H / 15/08/18 /	2.4. Alteration to ventilation Strategy
I / 29/01/19 /	2.5. New Sash Windows to facade
J / 29/05/19 /	2.7. Louver added to elevation for ventilation to WC's
K / 30/10/19 /	2.8. Colour coding added to revised drawing RevG
L / 29/01/19 /	Retrospective Planning for Dome Propping up works. Ref: 2019/0695/L
M / 11/02/2020	Proposed Dome LBC Application for: 1. Permanent Dome Truss. 2. Dome Front Pier PFCs. 3. Replacement of Dome Copper Roof

PLANNING

project title	KOKO + Hope & Anchor + Bayham Place Camden, London
drawing title	Proposed Second Floor Plan
drawing number	AHA/KKG/GA/102
scale	1:100 (A1)
date	13.04.17
drawn	FR/PC
checked	DA
revision	M

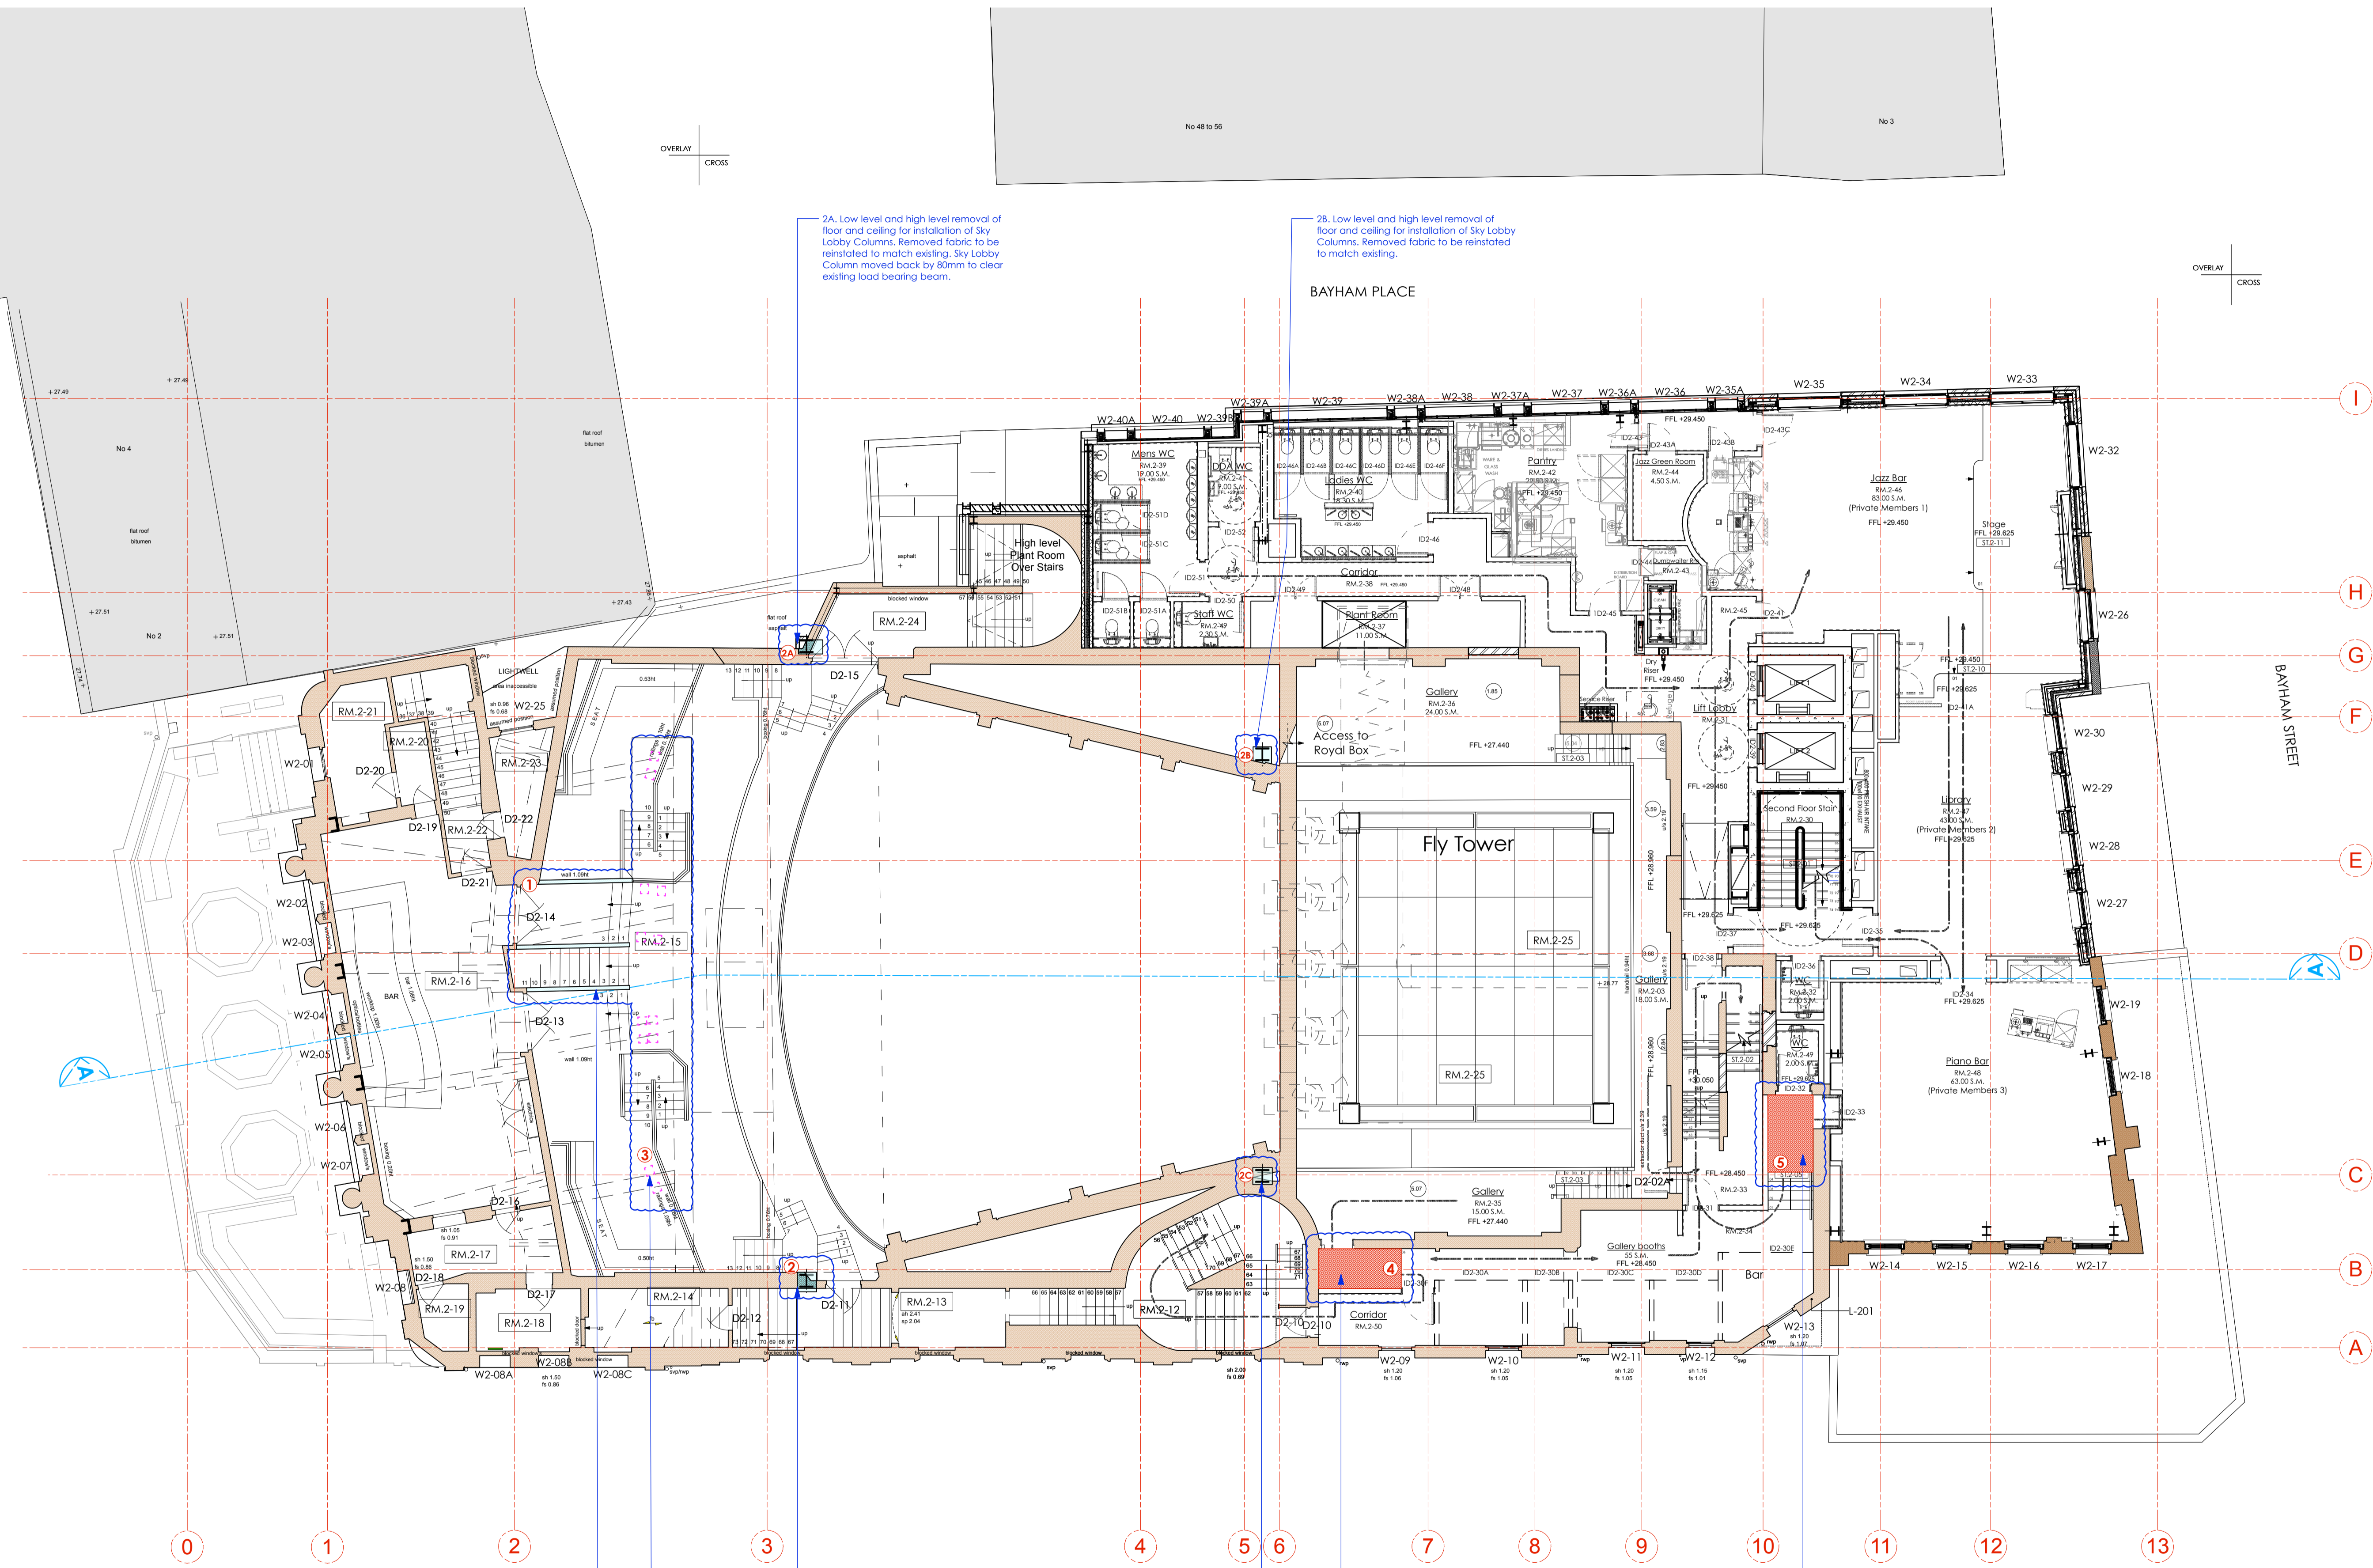
1. Following review of PFC location, PFCs to be chased into front piers and concealed. PFC size 400 x 200 D x 10 T. 2. Retrospective Planning for removal of listed fabric around temporary propping up works for Dome Truss. 3. Removal and reinstatement of high level H/L. 4. Removal and reinstatement of low level L/L. 5. Change to consented proposal. Refer to colour coded legend and annotations 1-5.

1. Existing area of balustrade removed for installation of temporary propping up works for Dome truss. Balustrades to be replaced to match existing.

2. Low level and high level removal of floor and ceiling for installation of Sky Lobby Columns. Removed fabric to be reinstated to match existing.

3. Temporary Propping locations.

4. Area of floor to demolished for proposed consented works.

5. Area of floor to demolished further for proposed consented works.

2A. Low level and high level removal of floor and ceiling for installation of Sky Lobby Columns. Removed fabric to be reinstated to match existing. Sky Lobby Column moved back by 80mm to clear existing load bearing beam.

2B. Low level and high level removal of floor and ceiling for installation of Sky Lobby Columns. Removed fabric to be reinstated to match existing.

2C. Low level and high level removal of floor and ceiling for installation of Sky Lobby Columns. Removed fabric to be reinstated to match existing.
